18-583 Landing Gear retract crank
Drawn 8/3/02 by Bob Kuykendall
Copyright 2002 HP Aircraft, LLC
HP-18 design by Richard E. Schreder

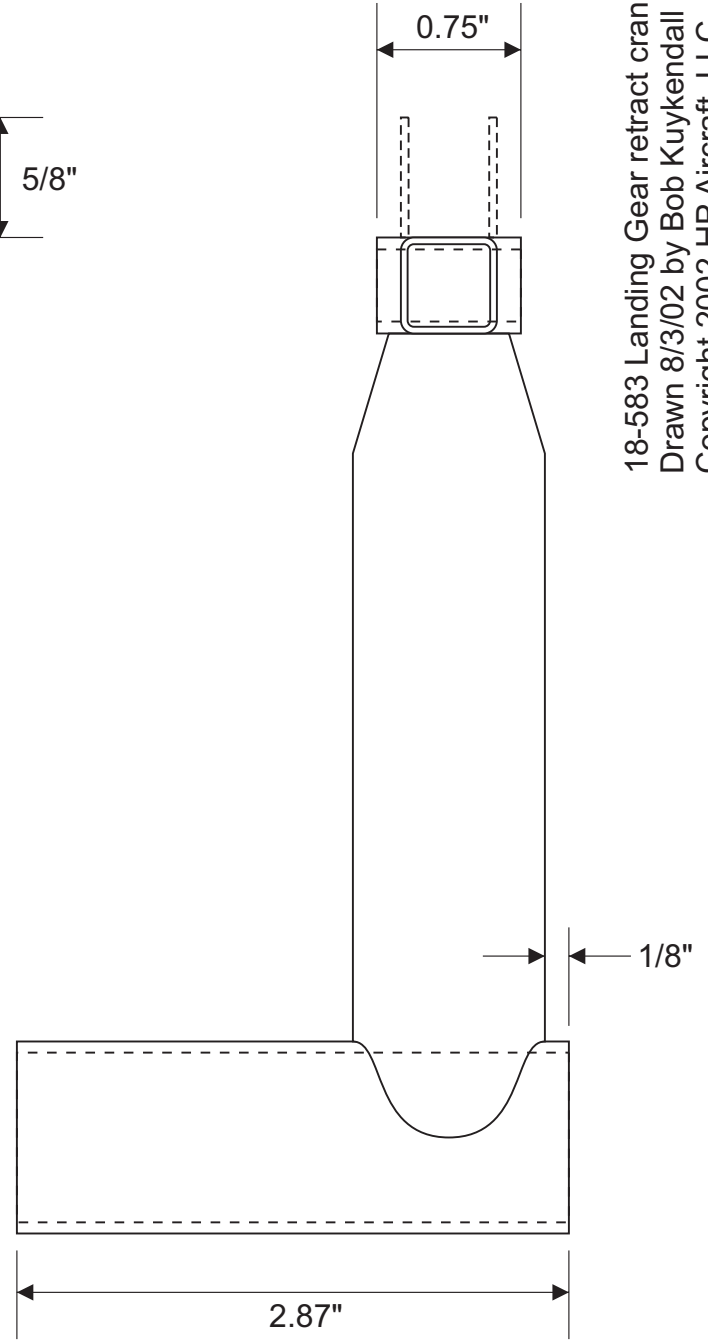
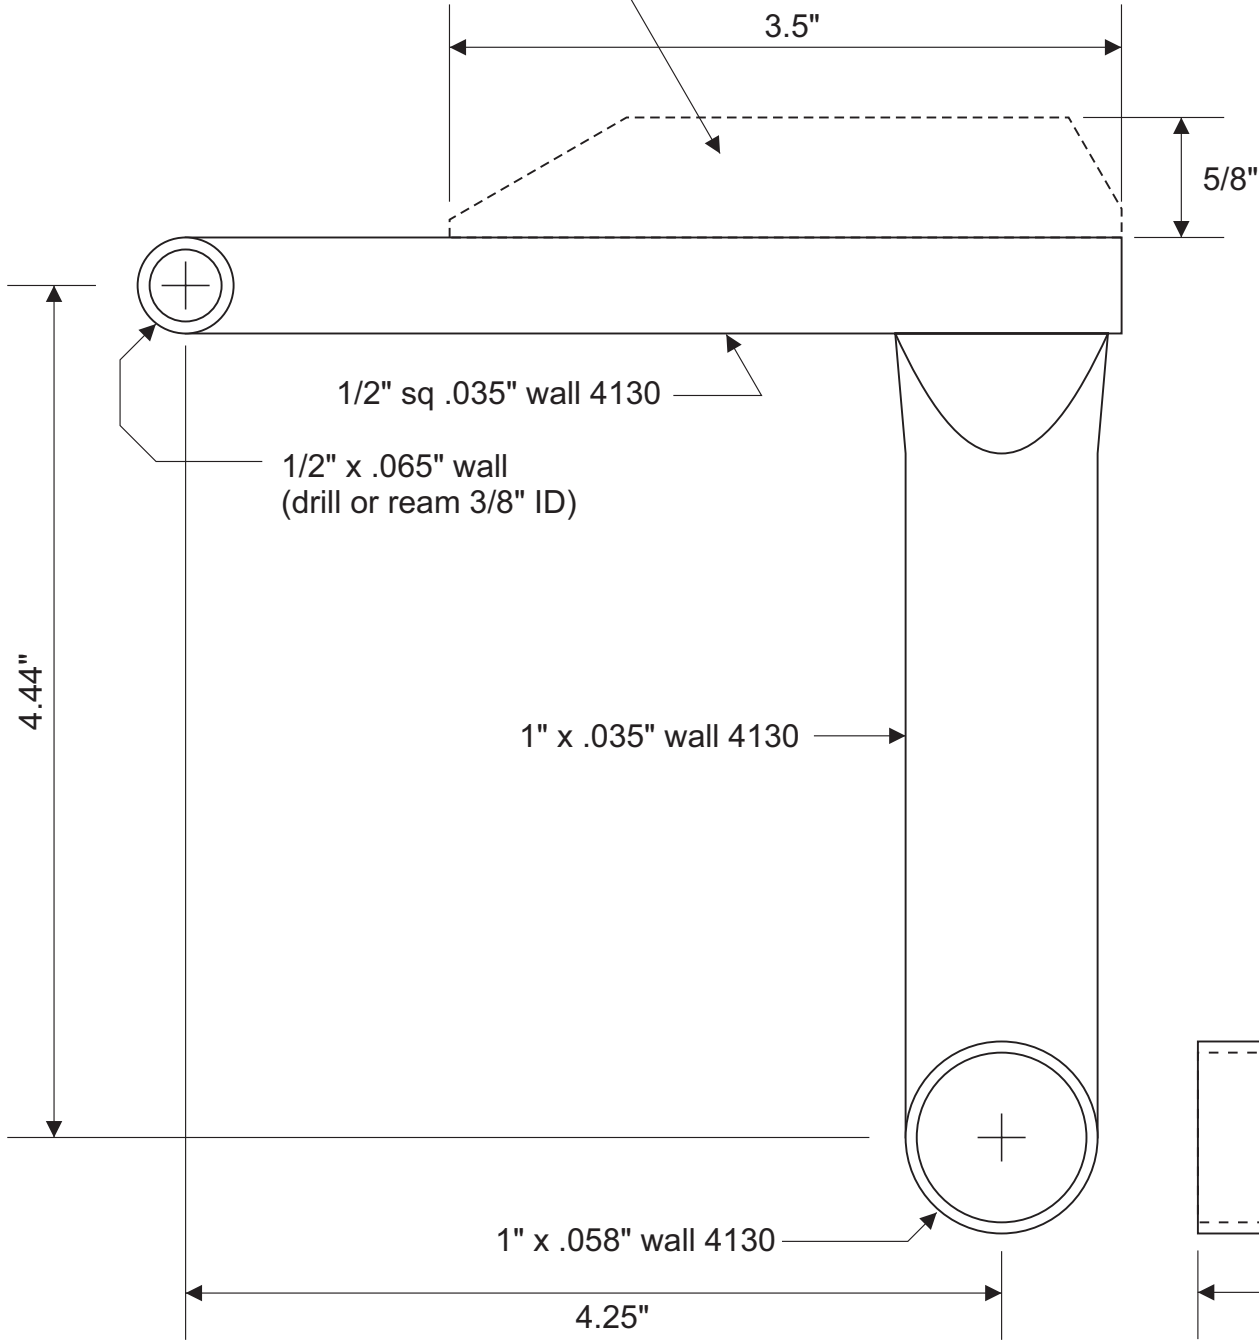
Some operators add
.040 thk gussets as shown
